## Detailed Site Plan Royal USA Tours

## DSP-23018

STAFF REPORT

SUBJECT: Detailed Site Plan DSP-23018  
Royal USA Tours

Figure 2: West, South and North Elevations (View from Top to Bottom)

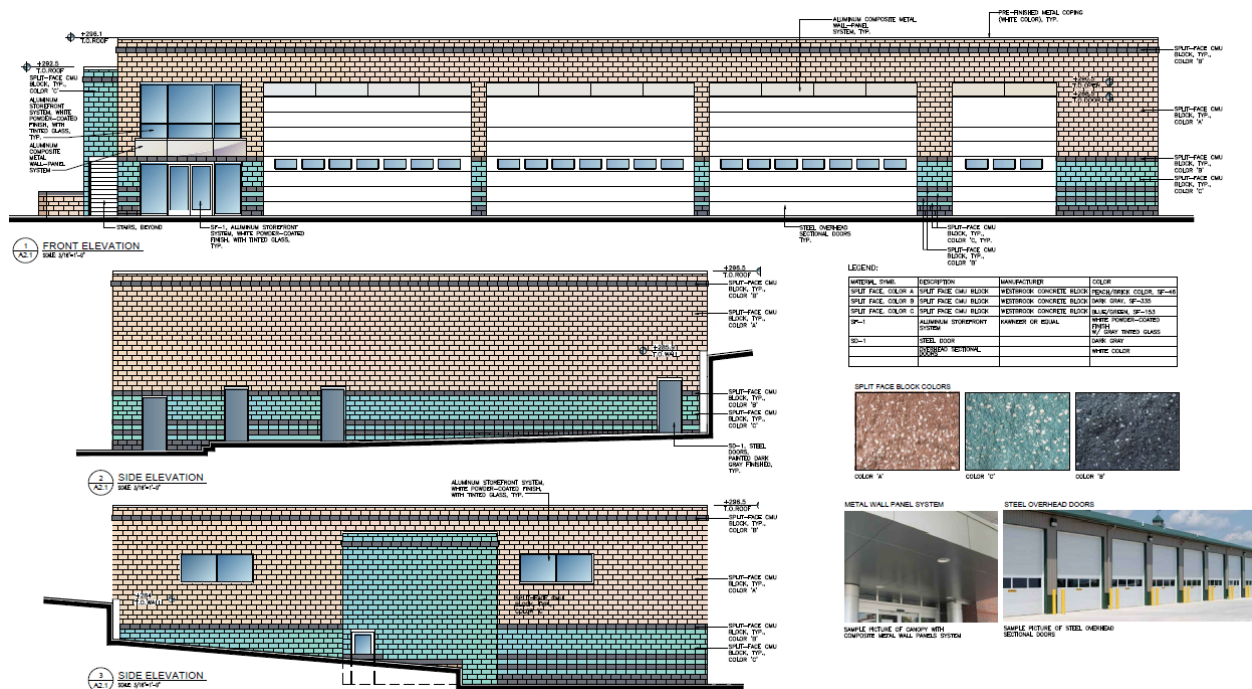
The architectural design of the proposed building will be a typical, contemporary, industrial building, generally square with a flat roof. The building is finished with a mix of materials including split-face concrete masonry unit blocks, aluminum composite metal, and glass. These building materials are proposed across all façades of the building, to ensure a unified and harmonious use of materials and style. Three different colors of concrete masonry unit blocks will create patterns to enhance the attractiveness of the building and avoid blank walls. There is a discrepancy between the building floor plan shown on Sheet DSP-4 and the south elevation shown on the architectural elevations sheet, which is conditioned herein for technical correction.

1. Prior to certification, the applicant and the applicant's heirs, successors, and/or assignees shall revise the detailed site plan, as follows:
  - a. Revise the south elevation of the proposed building to be consistent with the floor plan of the proposed building.

- b. Label the building heights on the architectural elevations.
  - c. Label the setback of the sign proposed to be mounted on the fence along Hazelwood Drive, from a street line on the plan.
